Sheet: /
File: GatedEnvelopeFilter.sch

Title: EnvelopThresher

Size: A4	Date:	Rev: R2
KiCad E.D.A. kicad 4.0.7		Id: 1/2

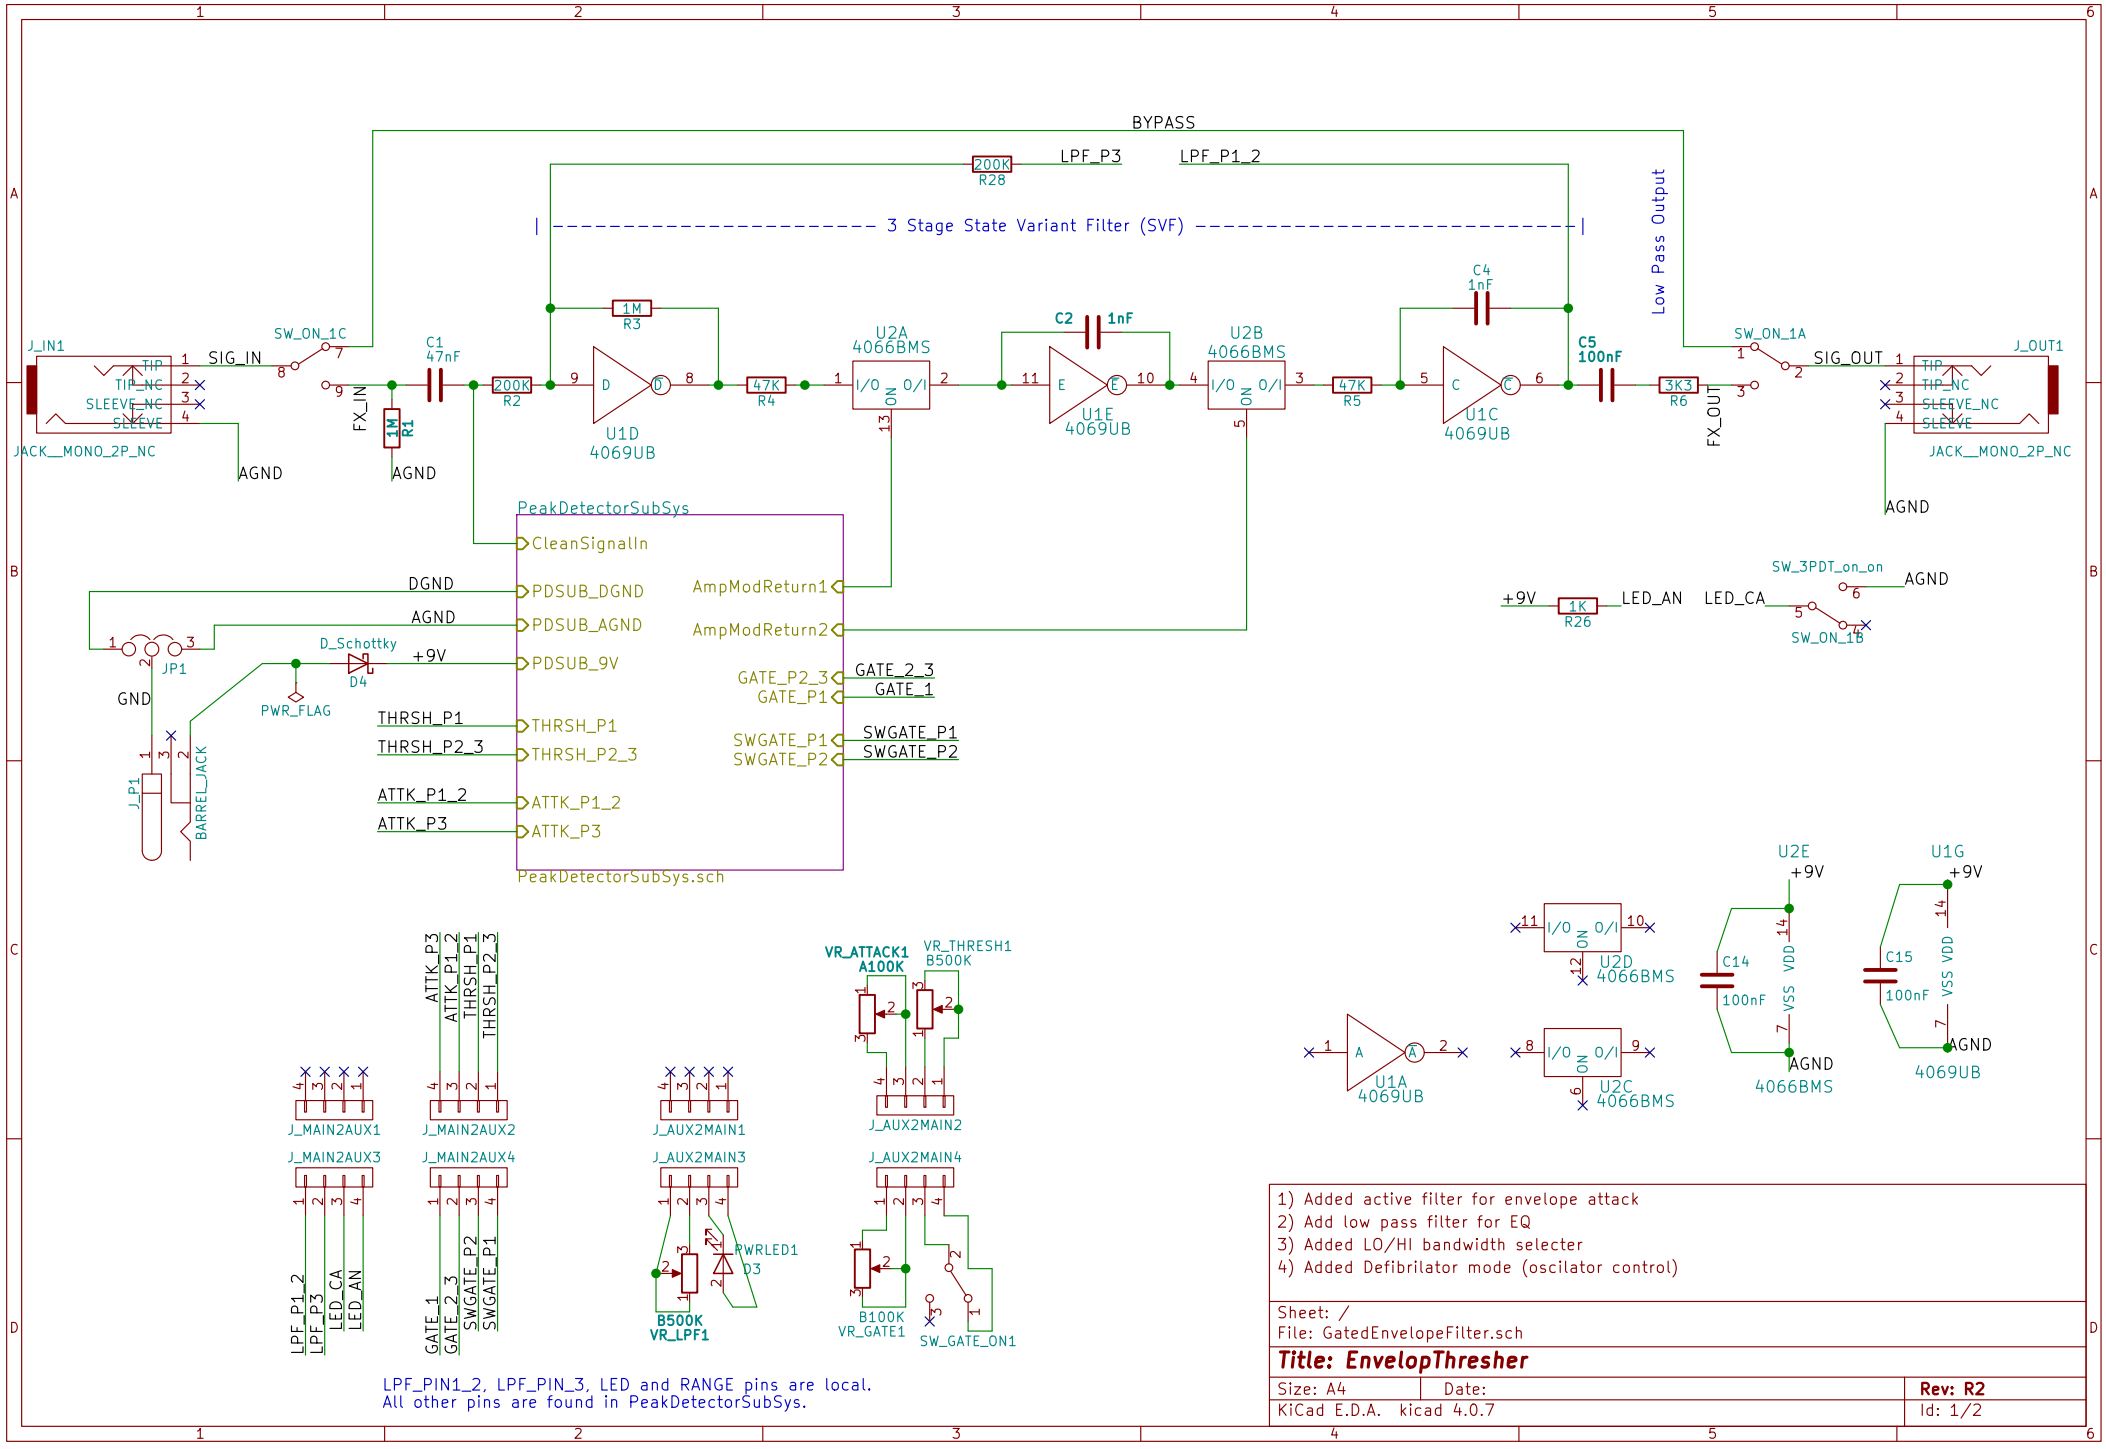
1) Added active filter for envelope attack
2) Add low pass filter for EQ
3) Added LO/HI bandwidth selecter
4) Added Defibrilator mode (oscilator control)
